R66 SERVICE BULLETIN SB-18A

SUBJECT: MRGB Output Yoke Retaining Plug

ROTORCRAFT AFFECTED: R66 Helicopters S/N 0004 thru 0707.

FIGURE 1

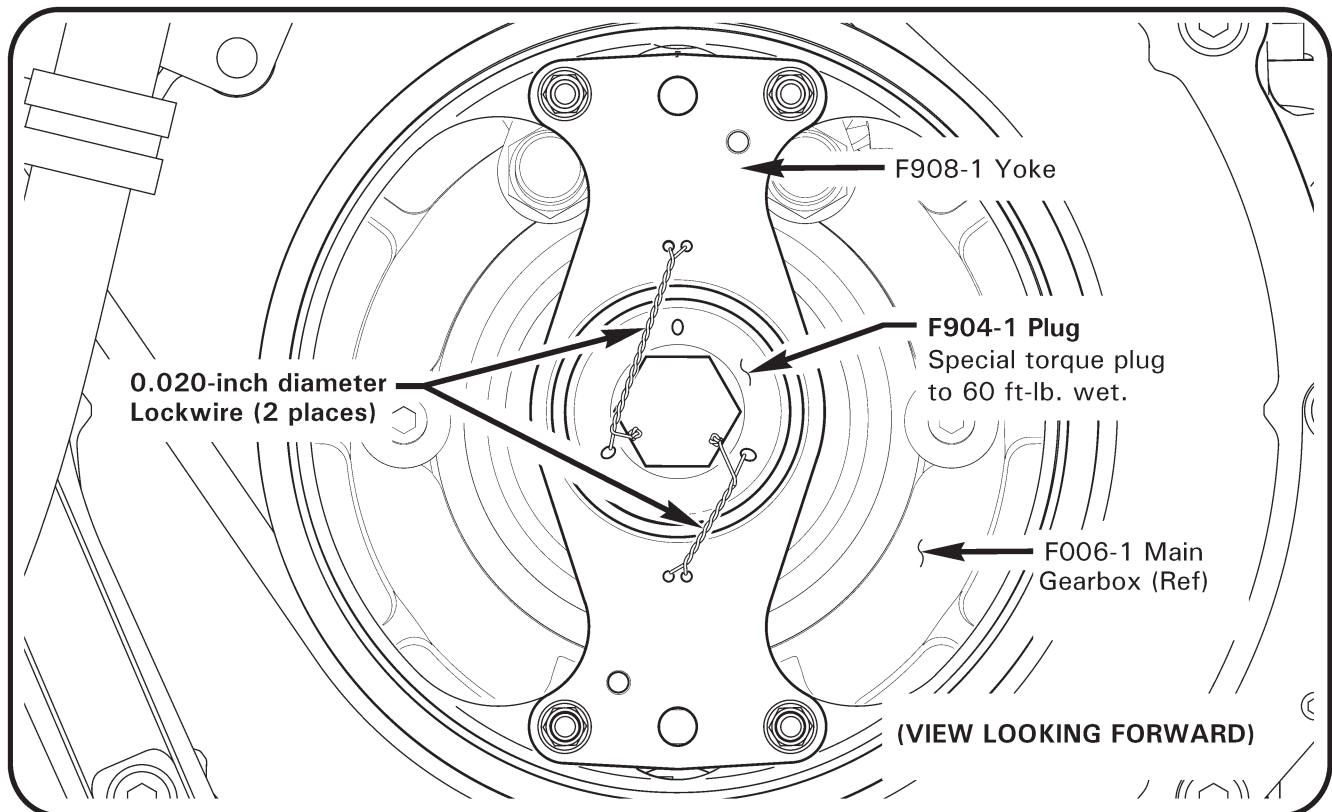
6. In two places, install 0.020-inch diameter lockwire and safety plug to yoke with pigtails inside recess of plug as shown.
7. Install forward C947-3 flex plate assembly, using hardware removed (replace palnuts). Standard torque hardware per MM § 20-32 and torque stripe per MM Figure 5-1. Ensure safety wire is not contacting flex plate.
8. Install and shim intermediate C947-3 flex plate assembly per MM § 65-30.
9. Install hardware securing aft F305-5 inlet to scroll assembly. Verify 0.10 inch minimum gap between fanwheel assembly and inlet.
10. Install tailcone cowling per MM § 53-23.
11. Make appropriate maintenance record entries. No change to helicopter weight and balance.
